# IEEE P802.3at Task Force Power Via MDI Enhancements

## ALT A Midspan requirements - updating the spec

Yair Darshan / Microsemi Corporation,  
March, 2009

# Type 2 100BT ALT A Midspan System 350uH vs 120uH system comparison

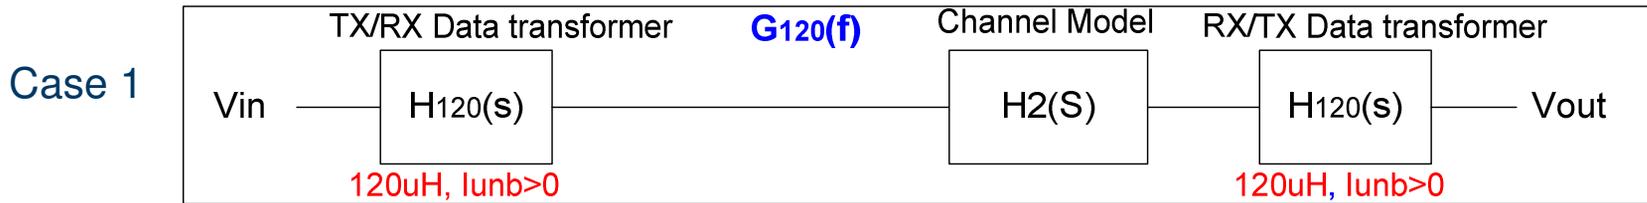
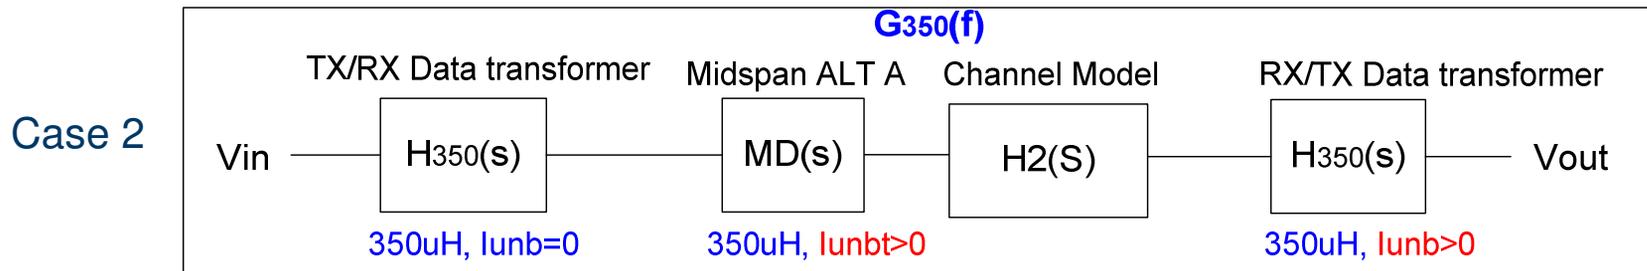
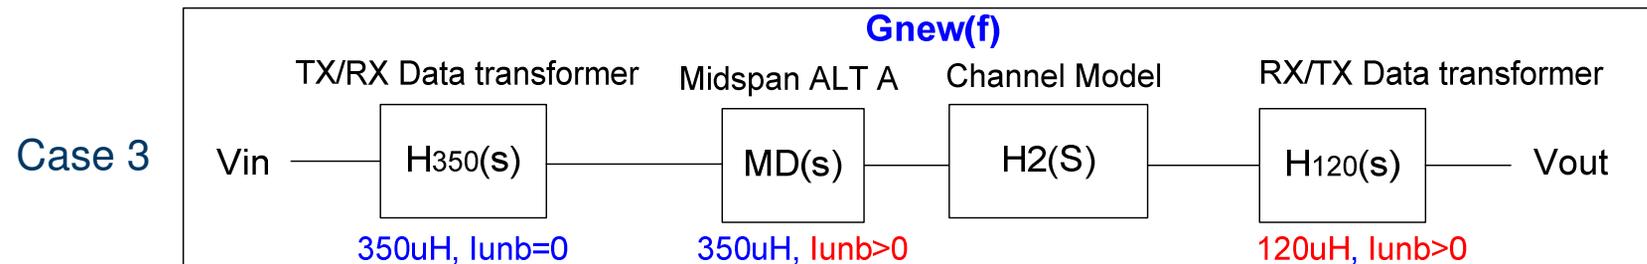
What is the difference in system performance between  $G_{new}(f) = H_{350}(s) * MD(s) * H_2(s) * H_{120}(s)$  and  $G_{120}(f)$  which is actually Eq 33-19 when  $OCL = 120\mu H$  only at the PD side?

- Eq 33-19 is not affected due to the requirement that Midspan need to regulate  $I_{n(b)}$  to Type 1 levels hence OCL in PD and Switch stays as in Type 1 systems i.e. 350uH minimum.
- At the worst case that Midspan is not regulating  $I_{n(b)}$ , it will change Eq 33-19 by 0.2dB max / 5deg (1.75%) as function frequency over the operating frequency range due to the 120uH minimum at the PD.
- Recommendations for Draft D3.3
  - When ALT A Type 2 Midspan is regulating  $I_{n(b)}$  to Type 1 levels, Eq 33-19 is not changed since it is a 350uH approved system.
  - When ALT A Type 2 Midspan is not regulating  $I_{n(b)}$  to Type 1 levels, Eq 33-19 need to be met as alternative.

"Alternative A Type 2 Midspan PSEs that support 100BASE-TX shall enforce channel unbalance currents less than or equal to Type 1 I<sub>unb</sub> (see Table 33–11) **or meet 33.4.9.2.**

# Eq 33-19 worst case gain difference between PD OCL= 120uH vs 350uH Midspan TF comparison: Simulation Verification

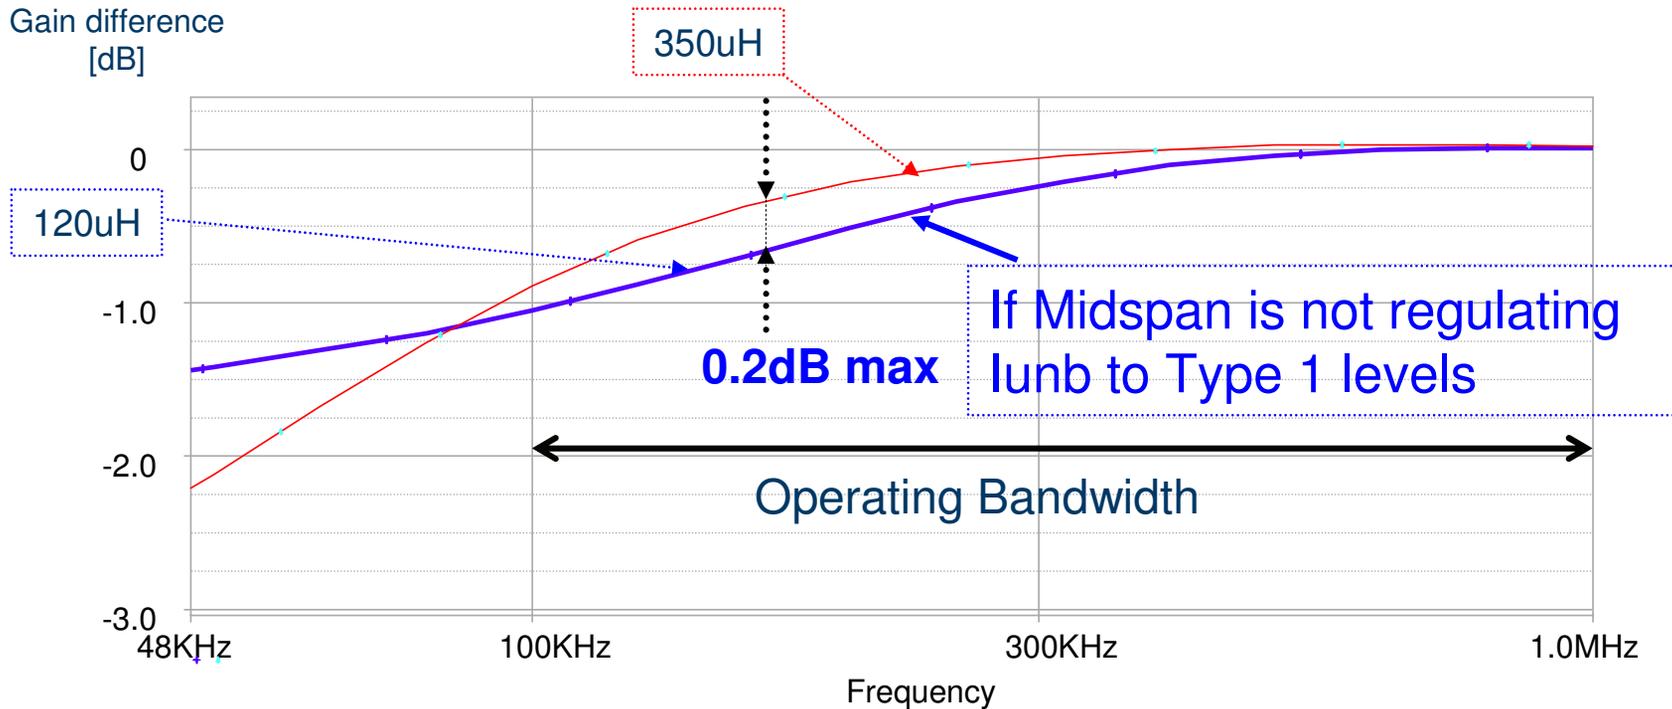
The worst case difference is 0.2dB and varies with frequency

# Eq 33-19 worst case phase difference between PD OCL= 120uH vs 350uH Midspan TF comparison: Simulation Verification

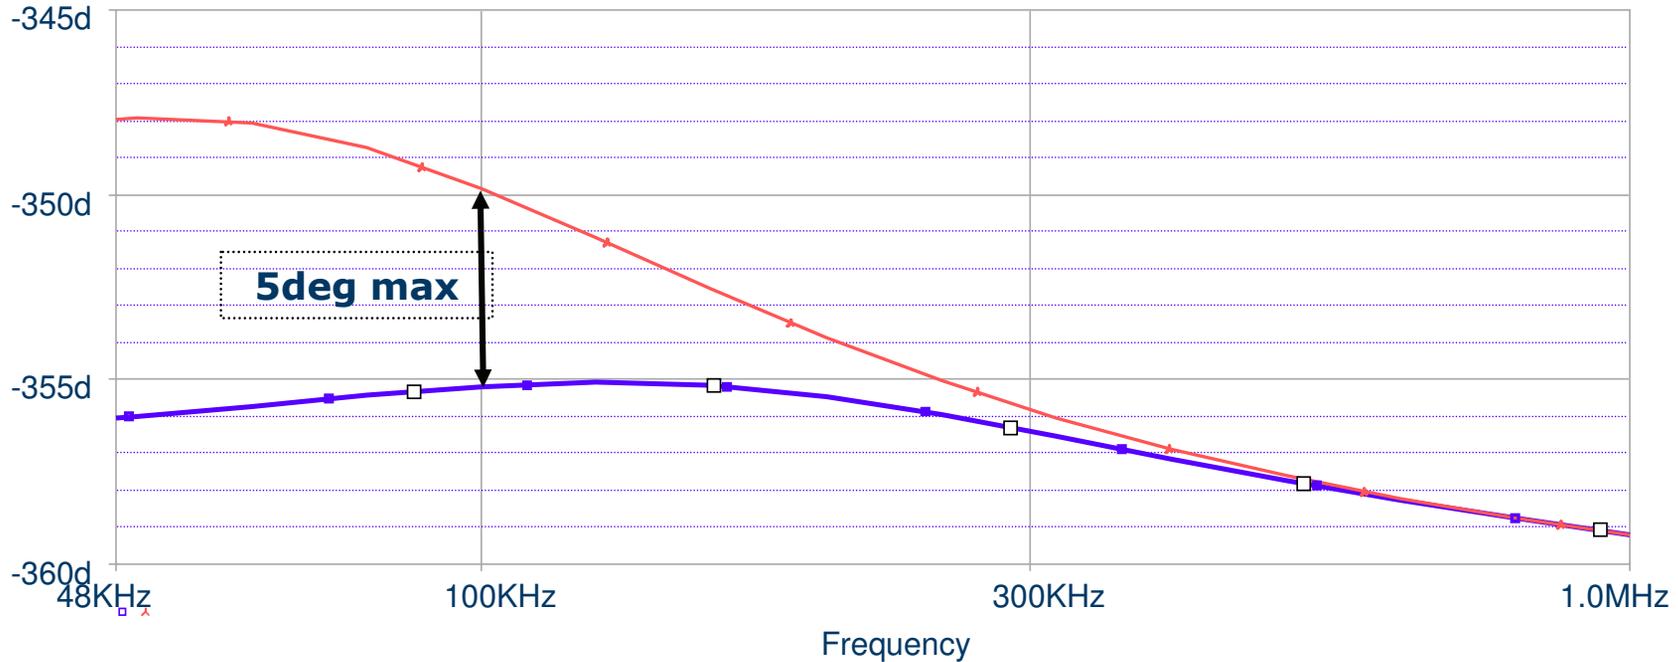
5deg max /270deg potential =1.75% max i.e. Dynamics are kept w/o significant change.
